## Index 536-001 Guardrail

### ORIGINATION

### COMMENTARY

**BLACK** = Industry Review Comments   **BLUE** = Standard Plans Response   **GREEN** = Change Made to Index

| LAST REVISION<br><del>11/01/25</del> | REVISION<br><b>11/01/26</b> | DESCRIPTION: | <br><b>FY <del>2026-27</del></b><br><b>STANDARD PLANS</b> | <b>GUARDRAIL</b> | INDEX<br><b>536-001</b> | SHEET<br><b>1 of 25</b> |

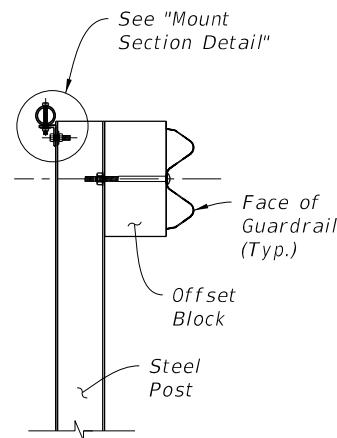
**COMMENT:** 536-001 Sheet 1 of 25, Note 7 – In some urban/intersection settings, I have had guardrail placed behind a road/curb-adjacent sidewalk. Designers have interpreted the phrase of “When guardrail posts are placed within 4’-0” of a sidewalk or shared use path, use...” and then dictated the use of pipe rail. It would seem that the primary intent of the pipe rail or wood post designation is intended to protect pedestrians and bicyclists who are separated from roadway traffic by a guardrail. If the intent is not to use pipe rail when a sidewalk is on the “panel-side”, but still within 4 feet – then I would advise to clarify the wording of this note

**RESPONSE:** This comment refers to language not proposed for a revision. Regardless, the Pipe Rail usage is clear because Pipe Rail would have no physical purpose for a sidewalk on the panel side. Also, the context for safety treatment on the back of post is included in the note, and the Pipe Rail usage definition on the Sheet 6 drawing shows the sidewalk location that applies for this topic. That said, since comprehension issues are a concern, the notes will be revised to ensure the sidewalk orientation shown on Sheet 6 is known.

**CHANGE MADE TO INDEX:** Yes. Updated Sheet 1, Note 7 and Sheet 23, Note 1.

7. ~~ADJACENT SIDEWALKS & SHARED USE PATHS~~ **BEHIND GUARDRAIL:** When guardrail posts are placed within 4'-0" of a sidewalk or shared use path, use timber posts, ~~or use steel posts only if treated with Pipe Rail as shown on Sheet 23.~~ **Alternatively, steel posts may be used if treated with Pipe Rail per Sheets 23 or Post Caps per the APL drawings.**
